Lakes & Waterways Advisory Board

April 9, 2019

Shoreline Alteration Permit Staff Report (Rip - rap)

Application #: 19-06 **WATERBODY:** Lake Maitland **Date:** April, 2019

Shoreline Alteration Permit Staff Report (Boathouse)

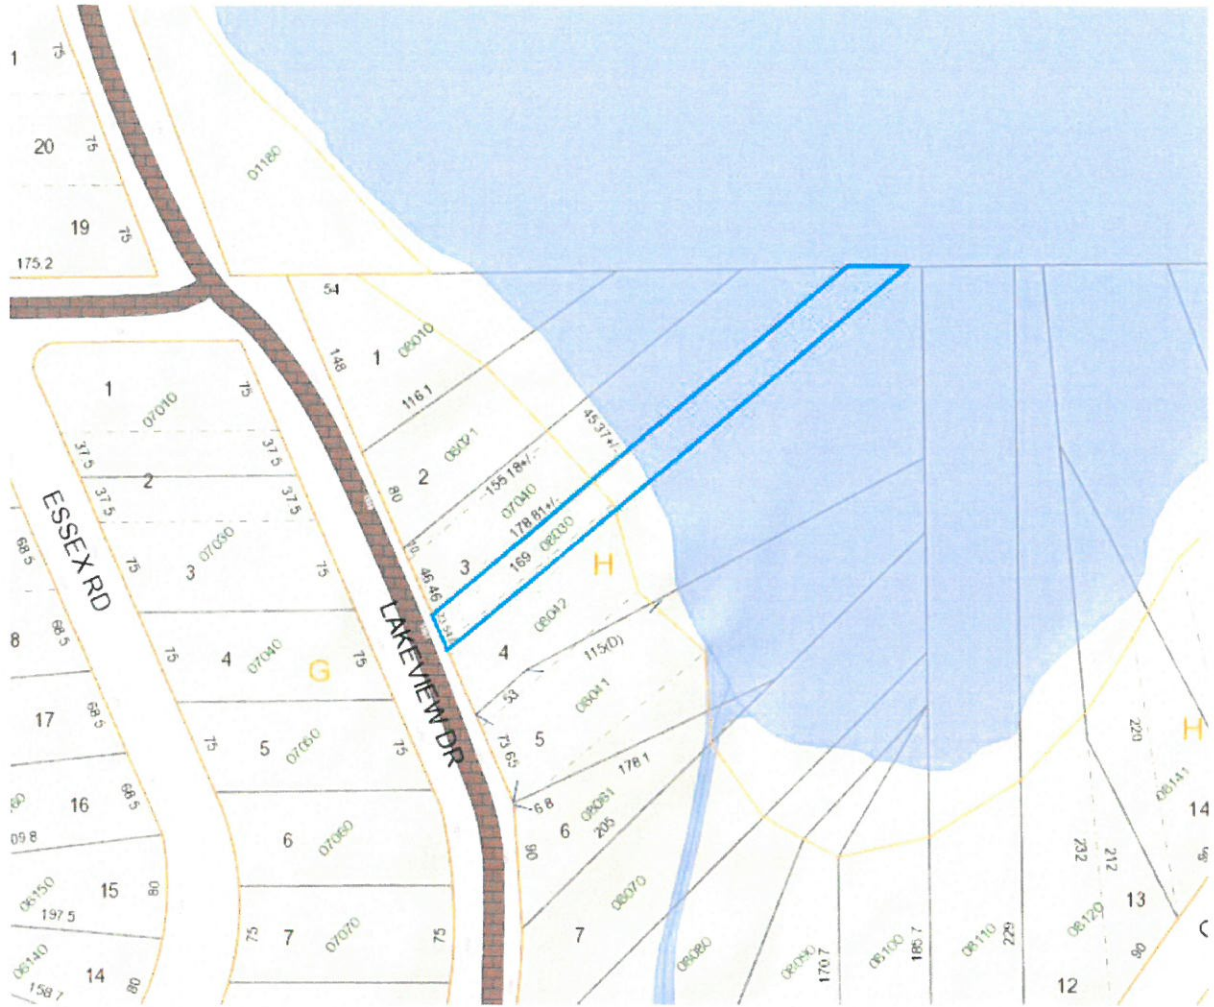
Letter of no objection obtained from neighbor. Vegetation compliance is not verified at this time. (4/4/2019).

Approval per approval of vegetation compliance.

Shoreline Alteration Permit Staff Report (Boathouse)

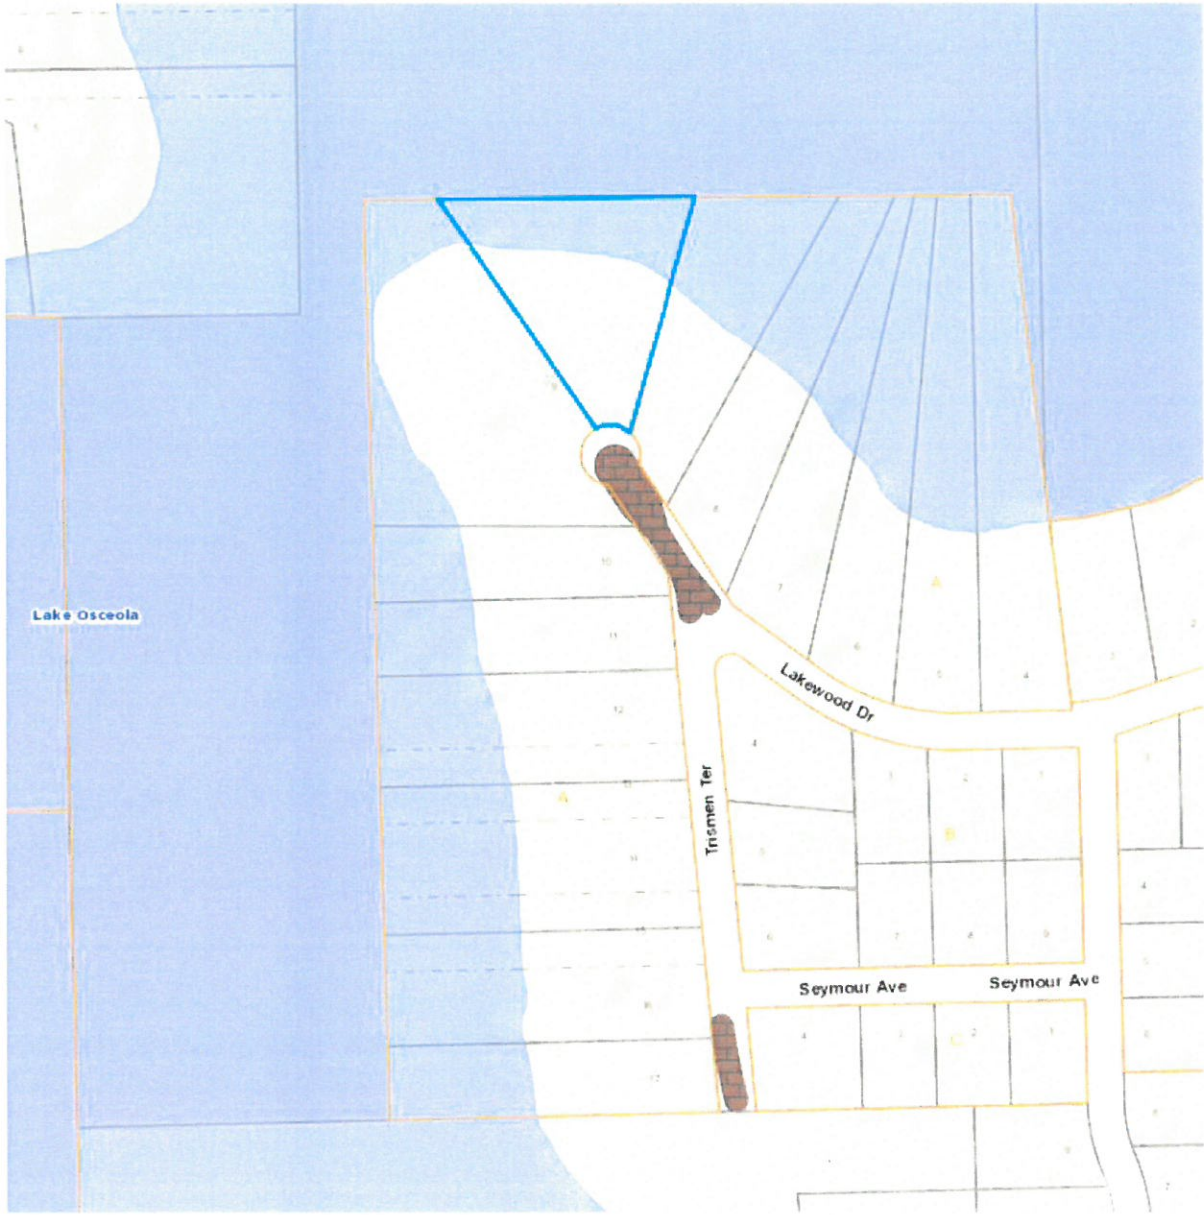
Length from OHW exceeds the allowable length, LDC Section 58-87. Flat roofs are not allowed, LDC Section 58-87. Property is not compliant with vegetation requirements, LDC Section 114.

Disapproval.
